N6701A-02A

Information Only Service Note

N6701A - Low-Profile Modular Power System

Different Color Front Panel LCD Display

Blue/white Front Panel LCD Display (below) has been obsoleted.

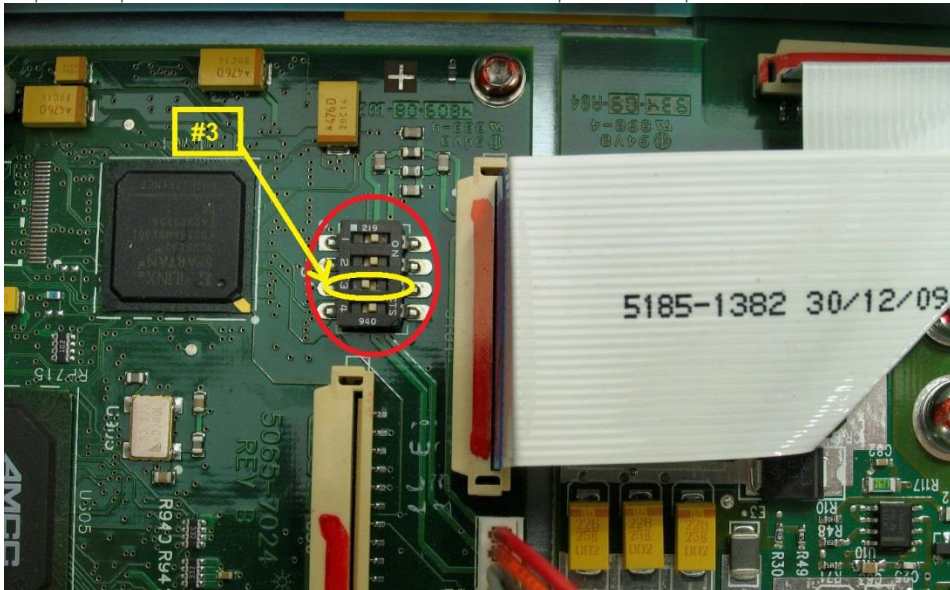
LCD (blue/white display assembly, part no. 2090-1031) has been discontinued by vendor. Replacement assembly (pictured later) is part no. 5067-5993 (amber in color). Difference in color doesn't impact any performance and specification. Unfortunately, this cannot be altered.

- 1) New LCD display (5067-5993) is a mechanical & functional “drop-in” replacement for the original.

- 2) 4-pole dip switch on PPMC PCA must have pole #3 repositioned to “off” as shown below:

- 3) Instrument firmware must be version D.04.01 or newer for proper operation of this display.
